# UNITED STATES PATENT AND TRADEMARK OFFICE

APPLICATION NO.	FILING DATE	FIRST NAMED INVENTOR	ATTORNEY DOCKET NO.	CONFIRMATION NO.
09/804,792	03/14/2001	Poramaste Jinupun		2022

# Office Action Summary

## DETAILED ACTION

(A) Core with Salient pole, each pole have teeth and windings.

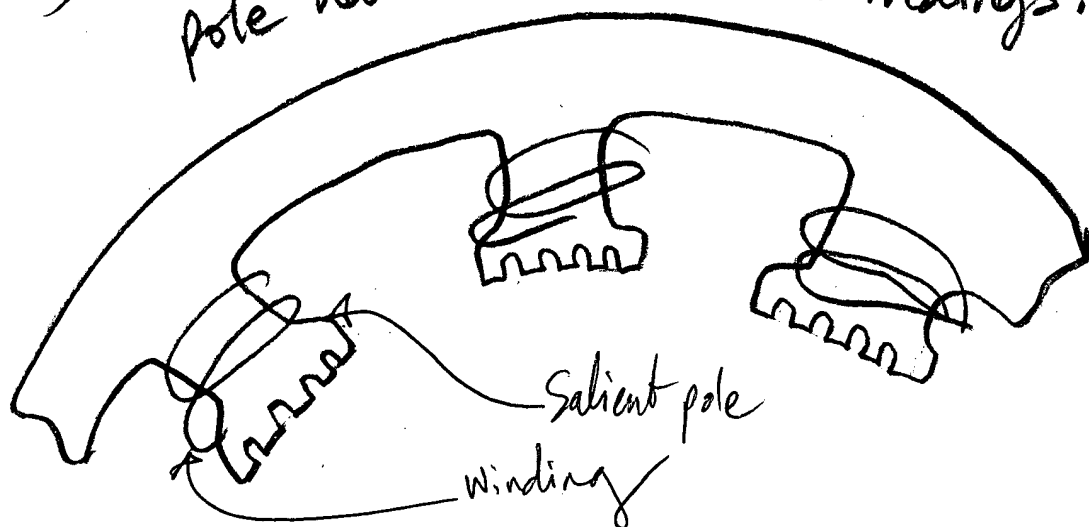
The drawings are objected to under 37 CFR 1.83(a). The drawings must show every feature of the invention specified in the claims. Therefore, *the salient poles of first assembly, wherein each pole subdivided into plural teeth, the windings wound one each or on alternate ones of respective teeth*, as in claim 1 lines 1-5 must be shown or the feature(s) canceled from the claim(s). No new matter should be entered. Note: Fig. 11d-22 show stator with plural poles, not each pole has plural teeth (see attachment).

The drawings of the claimed invention do not clearly distinguish whether the claimed invention is case (A) or (b).
